## **ARCHITECTURAL ADVISORY COMMITTEE MEMORANDUM**

DATE: May 18, 2020

SUBJECT: REQUEST BY PALO FIERRO ESTATES FOR MINOR ARCHITECTURAL REVIEW APPROVAL TO CONVERT 3,600 SQUARE FEET OF THE EXISTING LANDSCAPE AND INSTALL LANDSCAPE LIGHTING ON THE EAST LA VERNE WAY FRONTAGE AT 2082 LAGARTO WAY, ZONE RMHP, SECTION 26 (CASE NO. 3.700 MAA). (NK)

LANDSCAPE PLAN

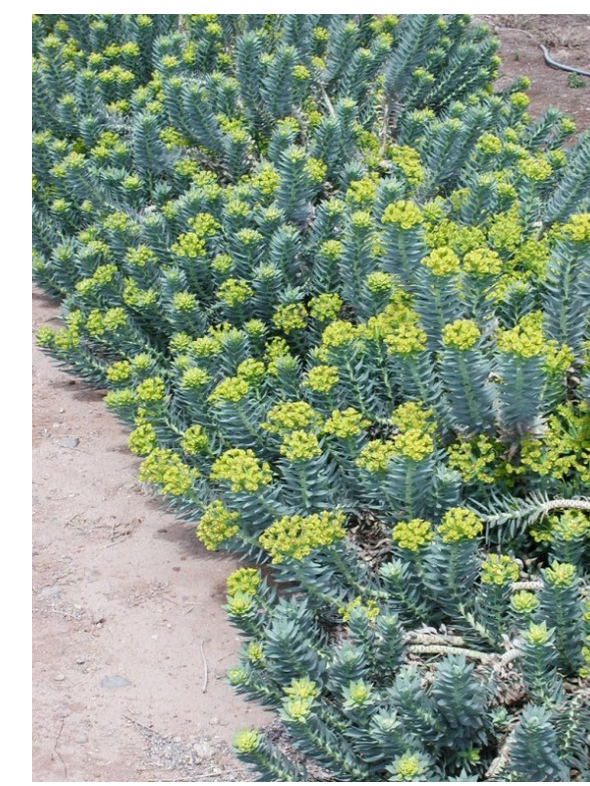
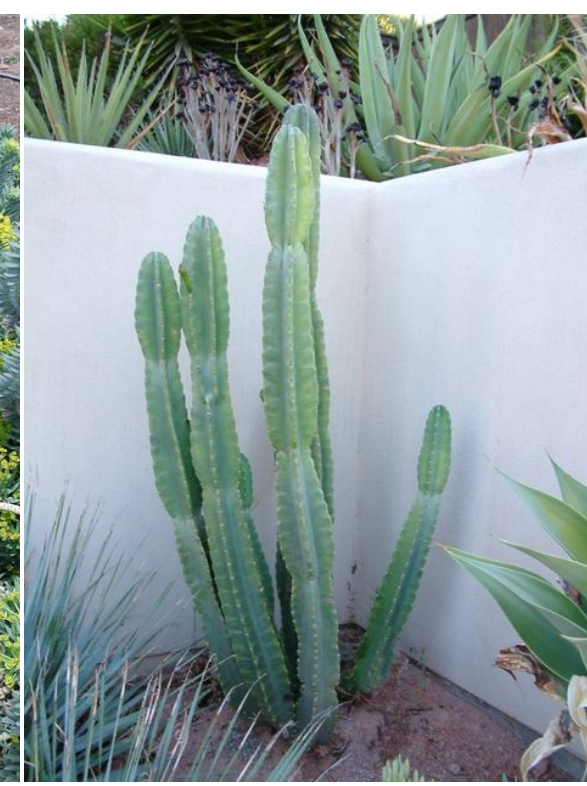
1. The proposed design lacks strong composition.
2. According to the information provided on the landscape plan, the total plant coverage area is 3,744 square feet. However, this is inconsistent with the information depicted on the plan as the coverage exceeds the total project area of 3,600 square feet.
3. The driveway entrance landscape treatment appears detached from the rest of the project area.

1. Rearrange and regroup Gopher Plant and Variegated Fountain Agave to create stronger composition by increasing the contrast between the open space and the plants.
2. Rearrange Gopher Plant and Variegated Fountain Agave in the corner areas for consistency.
3. Soften the edge of the driveway entrance landscape treatment so that it can be incorporated into the overall landscape design.

2. Square Footage. We do apologize; we did make a mistake when calculating our overall square footage's. We have corrected this on the included updated Plan, we failed to calculate in some planter areas that were not included in the turf replacement totals.

4. We have modified the plan to show the required 30' corner cutback in accordance with Attachment #2. Relative to the corner cutback area, visual obstructions are defined as any object that may block the view of motorists including utility vents, hills, walls, signs, street furniture or landscaping which exceeds a height of two and one-half (2 ½) feet above the nearest street pavement surface. The expected height of the one plant this would apply to in that area (Fountain Agaves) specified for that area would not exceed the 2 ½ ft limit. Please note that the corner on Lagarto Way and Laverne does not apply, as Lagarto is a private street, owned by the complex.
